# Hinckley National Rail Freight Interchange Written Representation

Stoney Stanton Action Group

October 2023

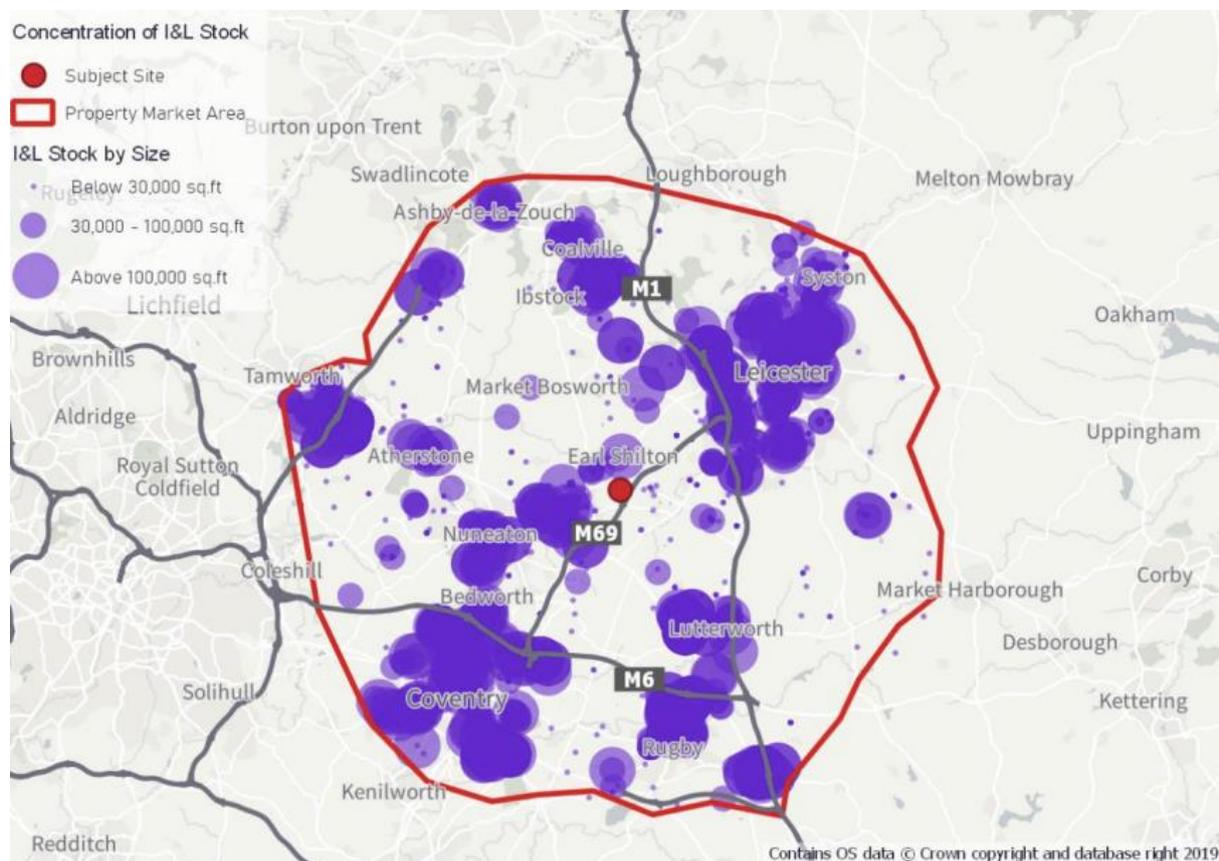
- 2.3 There are also many very large warehousing complexes in the area, such as Magna Park ~ 9km, one of the largest distribution centres in Europe, plus many large warehouse complexes recently built along the A5 near to Hinckley (although these are not easily accessible from HNRFI as they are on the West side of Hinckley). There is no need for additional warehousing in this area. The applicant has referred to a report “Warehousing and Logistics in Leicester and Leicestershire: Managing growth and change” April 2021 prepared by GL Hearn with MDS Transmodal Ltd and input from, amongst others, Tritax Symmetry (Hinckley). The report shows (executive summary para 0.4) that for “non-rail served sites”, if the planned extension at Magna Park is included, in Leicestershire there is a surplus of warehouse area up to 2041 but for rail served there is a deficiency (note their conversion of sq. m to hectares is incorrect and therefore the report overstates the amount in hectares). There are significant problems with the report if it is to be used as a justification for the HNRFI:

The report is Leicester and Leicestershire centric and does not address the wider status of the combined West and East Midlands. For a project of “National Significance”, the area considered should be across the whole region, not just Leicestershire. In the geographical area where the HNRFI is proposed, which is right on the “boundary” between East and West Midlands (the proposed site is on the western boundary of the East Midlands), there are several SRFI’s “just over the border” in the West Midlands, e.g., Birch Coppice, Hams Hall, Birmingham. DIRFT, just 15km away, is in Northamptonshire.
